SERVICE BULLETIN

#0014 Revision 2

SUBJECT: Rivet replacement along fuselage main spar carry-through and on upper and lower inboard wing skins

MODELS AFFECTED: All Sling aircraft manufactured before the effective date (04/09/2019)

Figure I - Paint cracking around rivets on Sling 2 wing

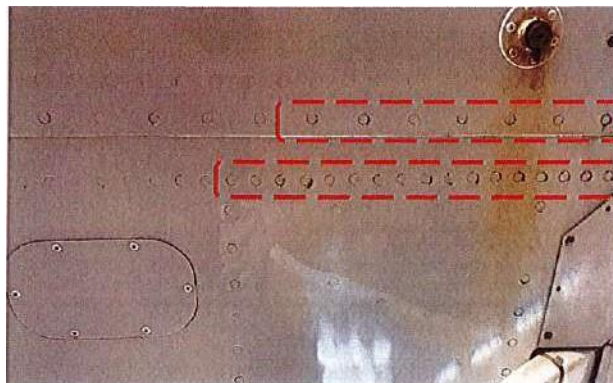
In some Sling aircraft, an indication of this condition is paint cracking around the rivets. The affected regions are usually located on the underside of the fuselage along the man spar carry-through and on upper and lower inboard wing skins. Figure I shows paint cracking on the inboard skins of a Sling 2 aircraft.

1. Rivet replacement on the Sling TSi is limited to the main spar carry-through only. The rivets on the inboard wing skins should not be replaced. Hence, only 62 rivets are required for the Sling TSi modifications.
2. Figure I demonstrates the fretting condition in aircraft and hence should not be used as a guide to the number of rivets that should be replaced.
3. Figure 2 and 3 demonstrate the general region where rivets should be replaced and hence should not be used as a guide to the number of rivets to be replaced.
4. The number of rivets recommended in this Service Bulletin should be adhered to provided fretting is not yet detected. However, for an aircraft with longer service hours, the affected region, and as a result the number of rivets, may increase as evidenced in Figure 1.

To minimise fretting, rivets in the affected areas should be replaced with Avinox stainless steel rivets (Part number BE61-00512).

Figure 2 — Region of rivet replacement on the underside of starboard (right) wing

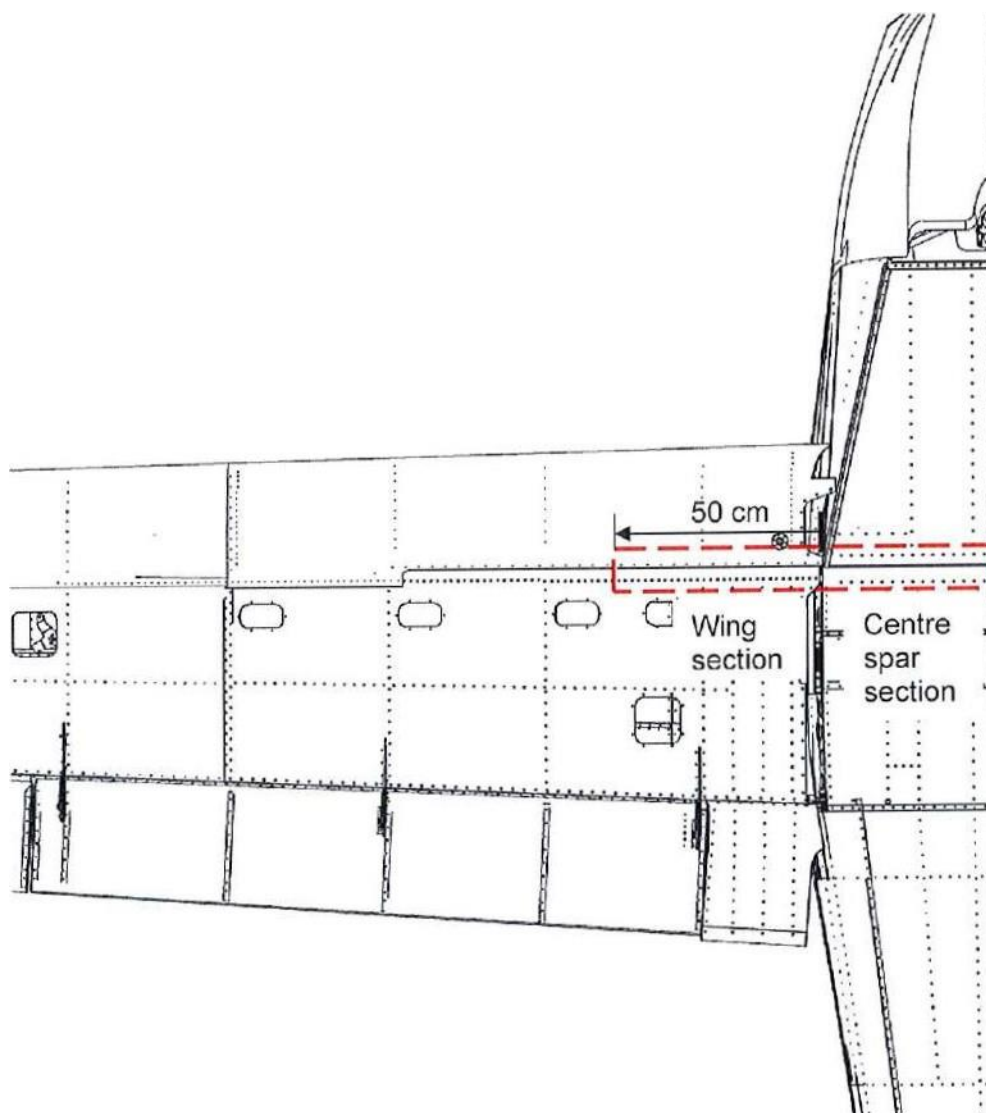
2. On the fuselage (of Sling TSi, Sling 2 and Sling 4 aircraft), this region is along the two rows of rivets that attach the underside centre fuselage skin to the centre spar (see Figure 2).

3. Figure 2 shows one half of the affected region on the underside of the starboard wing and fuselage and Figure 3 shows half the affected region on the upper starboard wing. The quantity of rivets recommended should cover these regions sufficiently.

The Figure 2 and 3 indicate the regions where rivets should be replaced on the aircraft. The rivets for the Sling TSi are replaced only on the centre spar carry-through under the fuselage.

5. Ensure that rivet removal is complete on the top of the wing before starting with the underside.
6. Using the powered drill with the 4 mm drill bit, drill the heads off rivets in the affected regions indicated in Figure 2 and 3 (specifically Figure 4 for Sling 2 and Figure 5 for Sling 4 wings). If rivets are filled, indent the centre of the rivet head with a centre punch and hammer before drilling.

Figure 4 - Number of rivets to replace on Sling 2 and Sling LSA wings

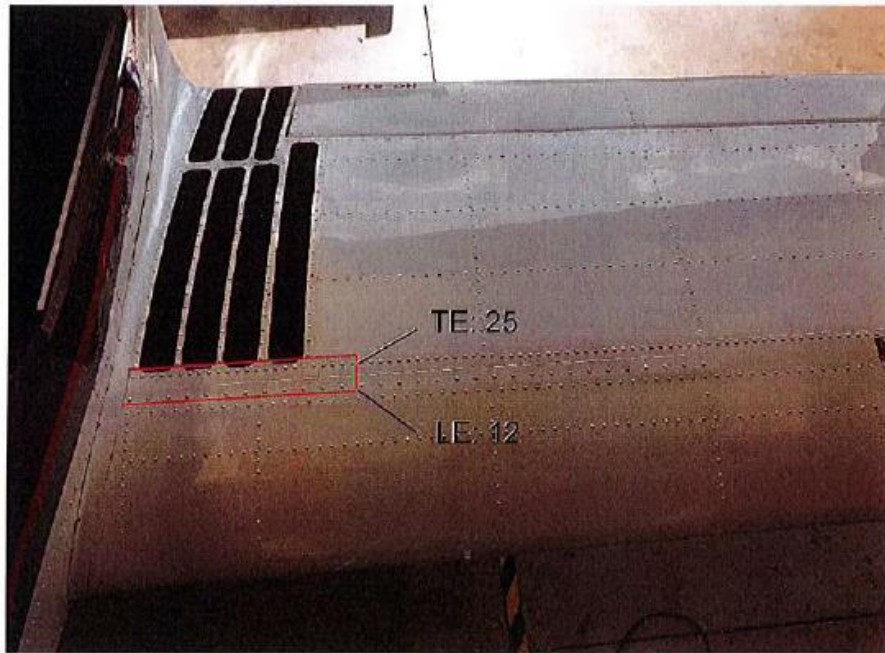
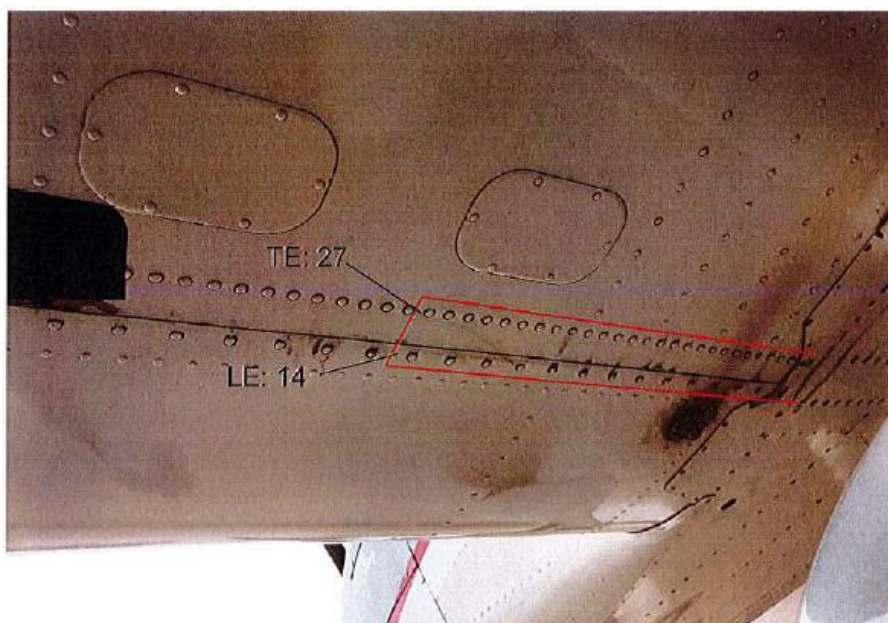
At approximately 50cm (spanwise distance) from the wing root, on the Sling 2 wings, the rivets to be replaced are 12 on the front section (leading edge) and 25 on rear section (trailing edge) of the upper wing spar. On the underside of the Sling 2 wing, the rivets to be replaced are 14 on the leading edge and 27 on the trailing edge as shown in Figure 4.

Hence, the total number of rivets, for both wings = $[(12 + 25) + (14 + 27)] \times 2$ 156 (wings only). The number of rivets along the centre spar carry-through under the fuselage 62 (centre spar only) In total: (156 + 62) 218 rivets (Sling 2)

Figure 5 - Number of rivets to replace on Sling 4 wings

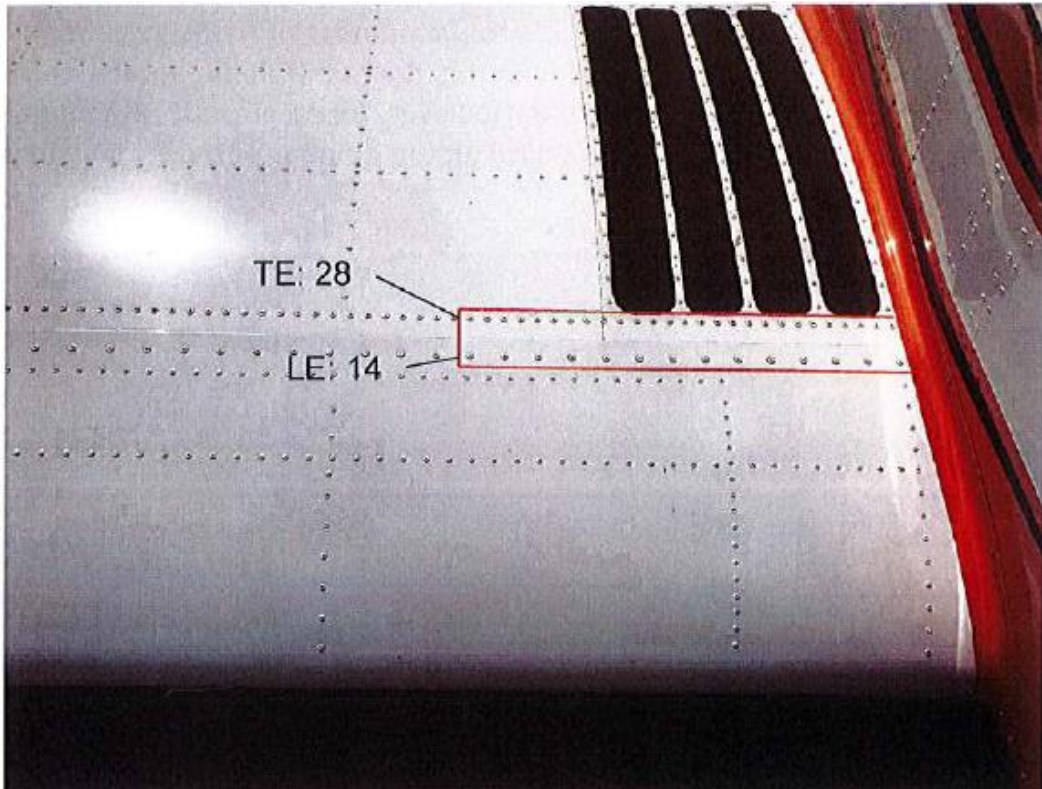
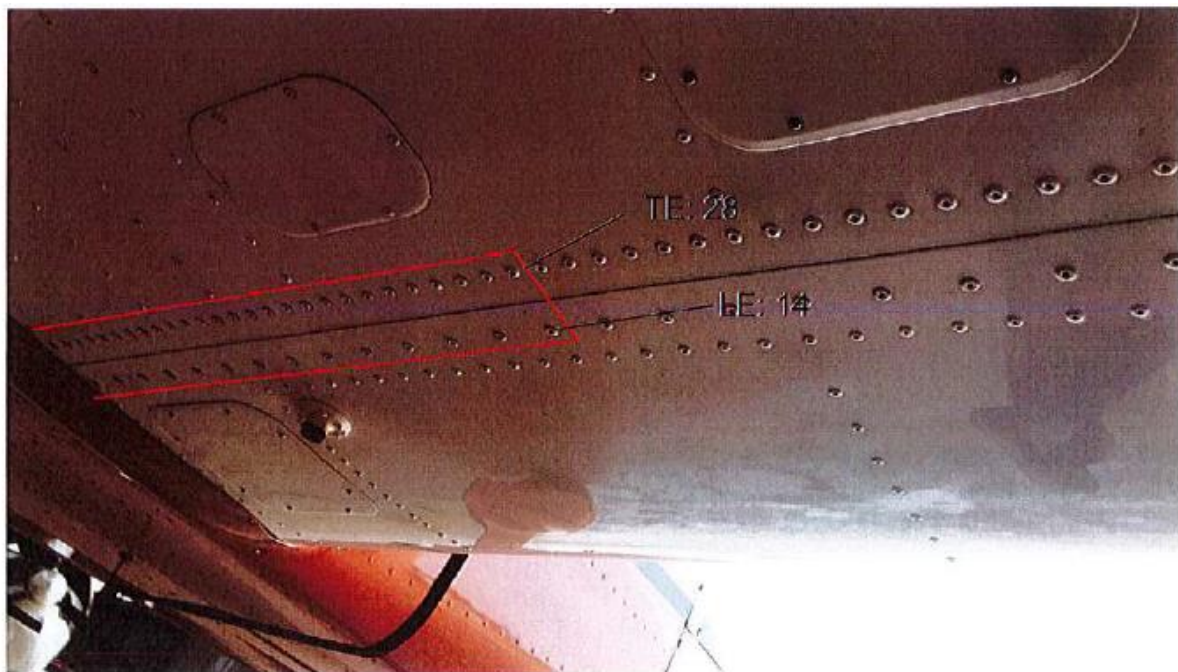
As illustrated below, on the Sling 4 wings, the rivets to be replaced are 14 on the front section (leading edge) and 28 on rear section (trailing edge) of the upper wing spar. On the underside of the Sling 4 wing, the rivets to be replaced are again 14 on the leading edge and 28 on the trailing edge. Hence, the total number of rivets, for both wings = $[(14 + 28) + (14 + 28)] \times 2$ 168 (wings only). The number of rivets along the centre spar carry-through under the fuselage 62 (centre spar only). In total: (168 + 62) 230 rivets (Sling 4)
